Species Management Corkscrew Regional Ecosystem Watershed (CREW): Florida Bonneted Bats

SFWMD and partners are restoring thousands of acres east of Fort Myers in Southwest Florida. SFWMD completed numerous federally required surveys under the auspices of protecting the Florida bonneted bat. As part of the ongoing restoration, SFWMD identified some new areas where the land needed to be cleared to ensure proper sheet flow. USFWS demanded SFWMD conduct more bonneted bat surveys, effectively shutting down the SFWMD effort on this piece of the project.

SoCREW Revisited
 July 8, 2016

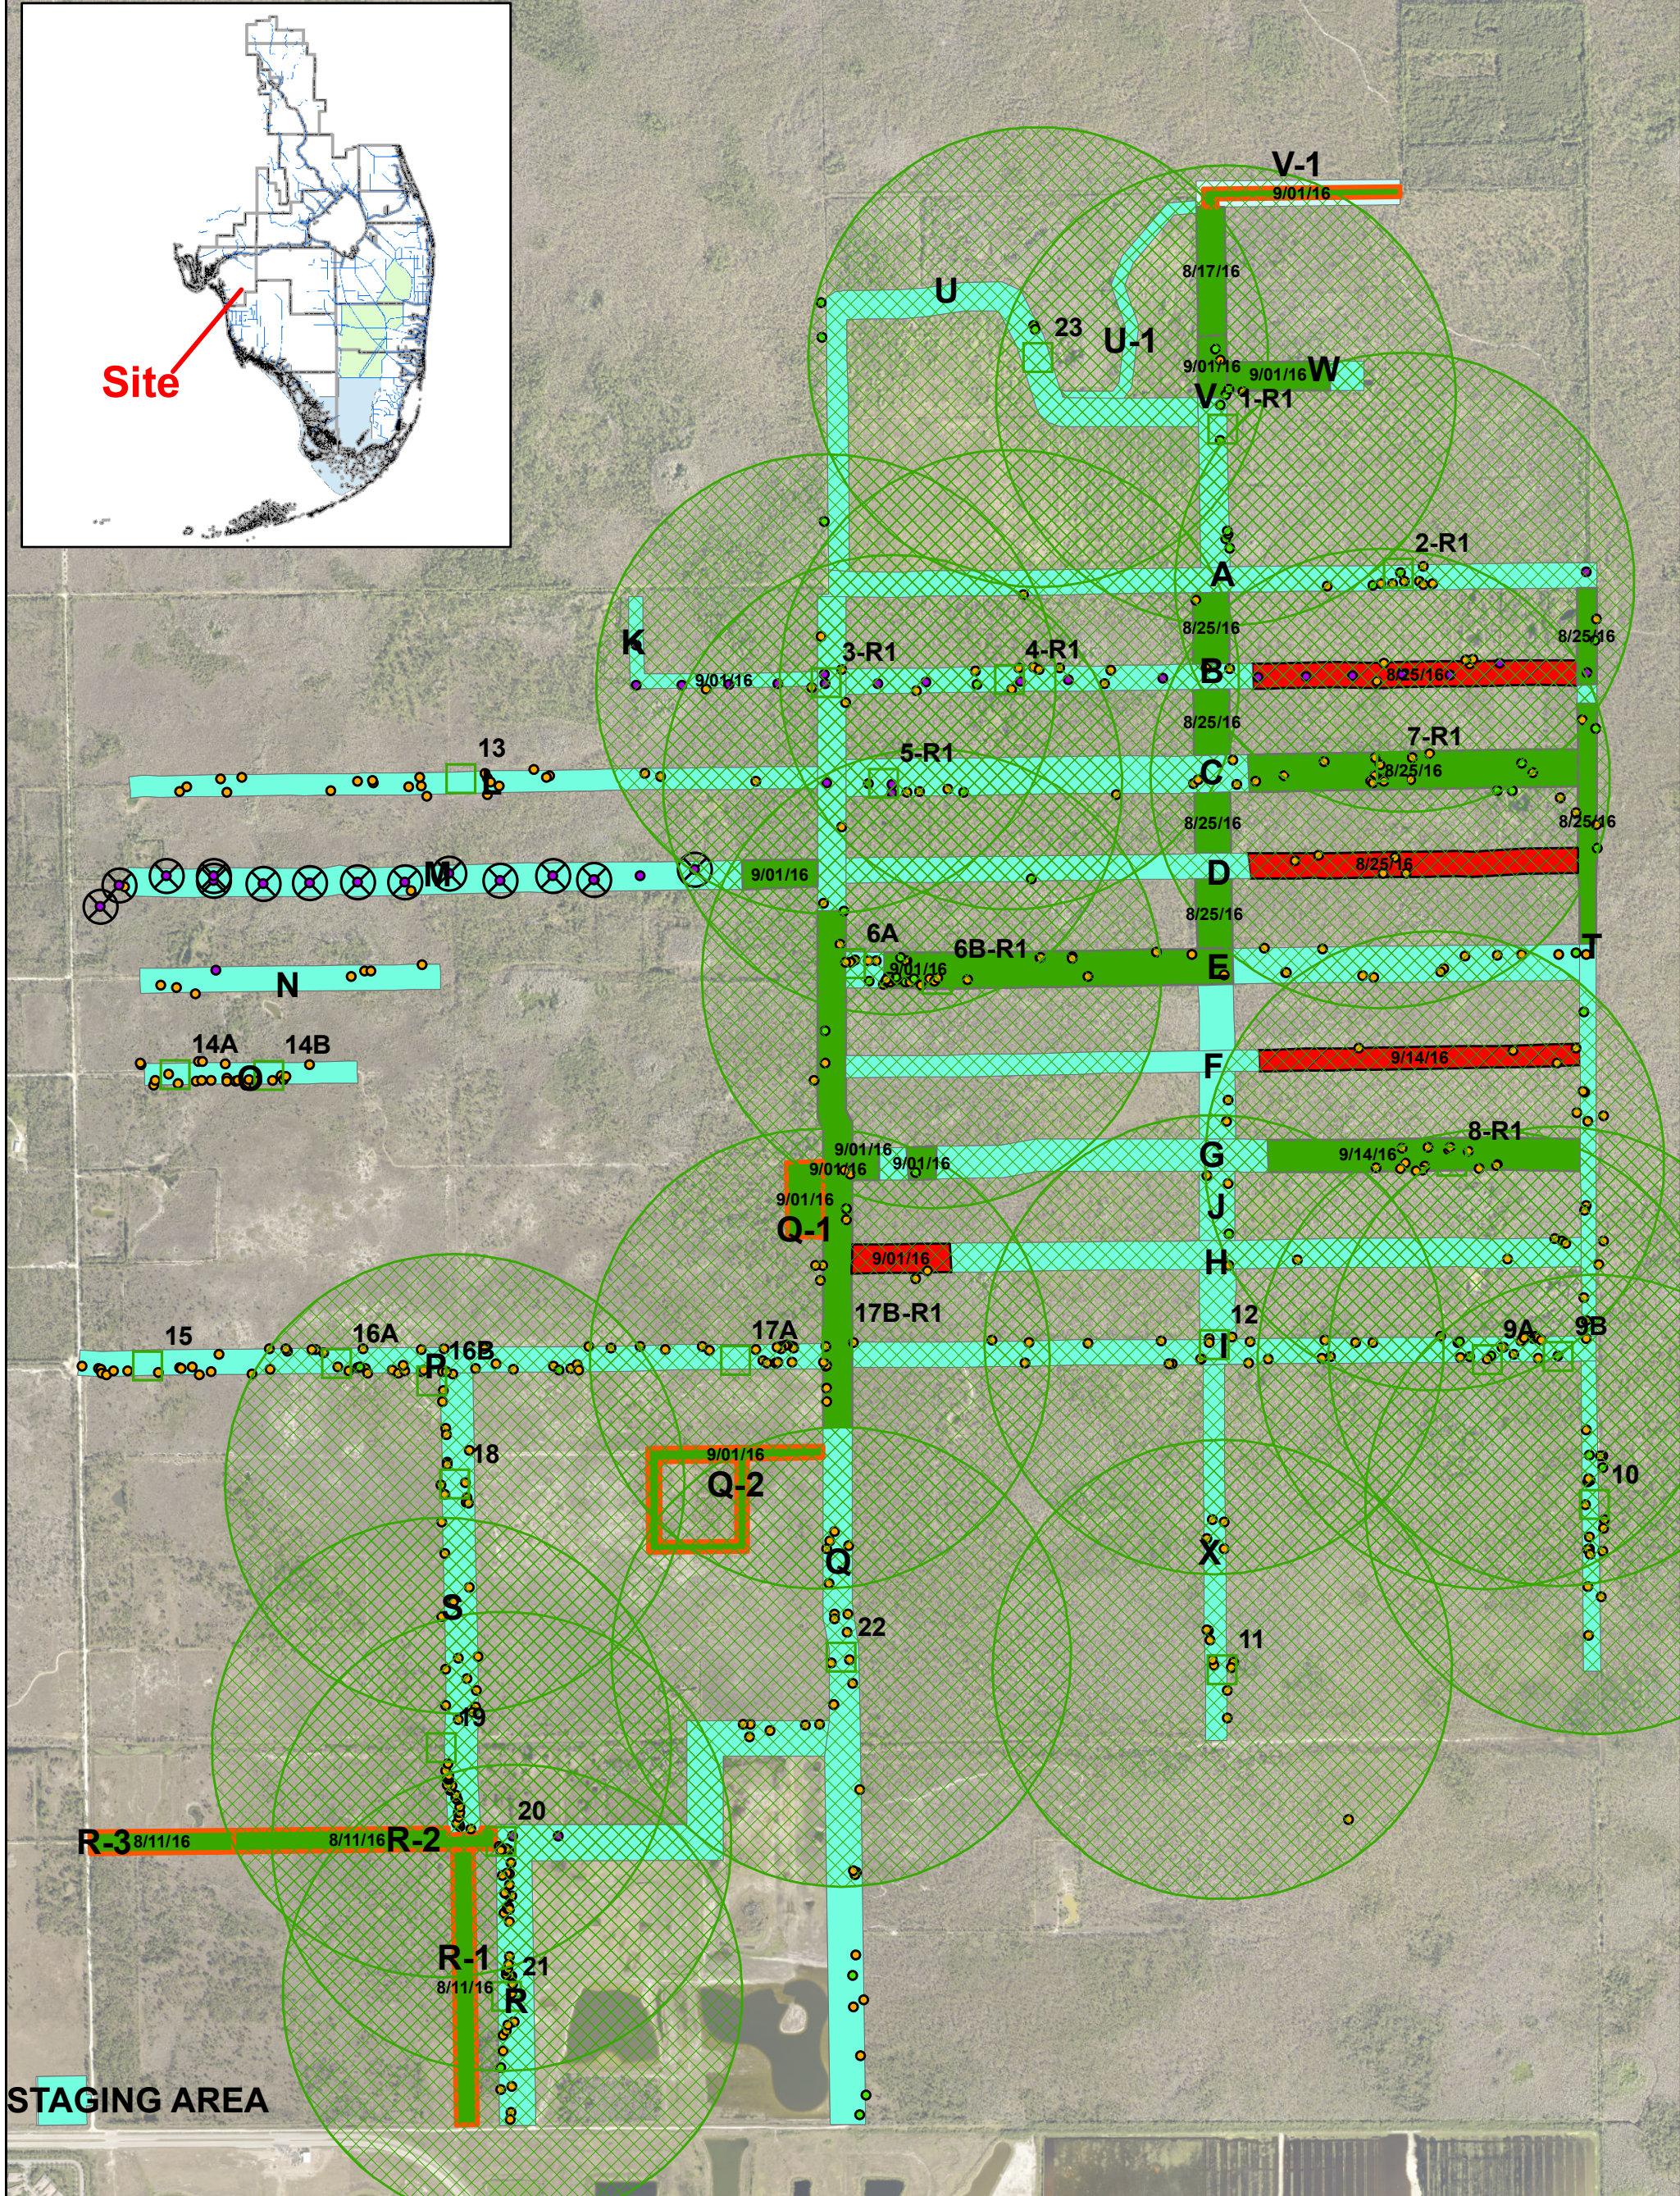
The main purpose of this email is that we have one location which falls just outside the monitoring exclusion zones of locations 19, 20, and 21. This area is part of what we are identifying as Alignment 7 on the attached map. The area that is just outside the monitoring exclusion zones is labeled as R-3 on the included Jpeg file. The R-3 Segment on the map is the Westernmost terminal end of Alignment 7. It is

Please find attached an updated revisited map which depicts the proposed revisions. We are proposing to avoid/not clearing 27.62 acres of the originally permitted footprint but instead add new areas for clearing totaling 27.61 acres. The District proposes new work on only 6 areas. The work consists of a minor addition of new area when compared to the overall project.

The attached map (FWS OK Map) depicts the 1,500 foot zones for the recently approved monitoring locations. As shown on the (FWS OK) map, the 6 areas of interest (7, 8, 10 a-b, 11, 12 and 13) have been monitored in the recent days. Active FBB acoustic monitoring was completed and approved by the Service, except for alignments 7 and 13, which have small sections/areas outside the original monitoring zones, however, the remaining proposed work areas have several overlapping approved monitoring zones from FWS.

Timing is critical since the District has an opportunity to commence clearing actions within the new areas on Friday July 22, 2016, without adversely affecting the project schedule. In addition, the next monitoring expiry occurs on August 11, 2016, and it affects Alignments 7 and 8. The District does not propose additional FBB acoustical monitoring.

The Service will need additional information from the District before we can approve construction within these new alignments. Please send Daryl an explanation about how your new

proposal is in line with the guidance and requirements found within the BO. Specifically, for any of the new alignments that you believe the previous acoustical surveys have "covered", we need to understand how you made that conclusion so we can determine if it is appropriate. For example, you may believe that alignment 8 is covered because the acoustical surveys conducted at sites 20 and 21 were close enough (150 foot buffer touches alignment 8)

For any of the alignments that need to be surveyed, please make a recommendation (number and location of acoustic surveys) for moving forward.

construction alignments (i.e, Phase 1 - identify large trees and snags; Phase 2a - acoustical surveys at high roost density sites; Phase 2b - focused FBB surveys, etc.). Therefore, in order to avoid a change to the proposed action which would require reinitiation of Section 7 consultation with the Service, either the phased approach or an equivalent survey methodology needs to be implemented along the new alignments before the Service will approve additional clearing. Please feel free to contact me with any questions.
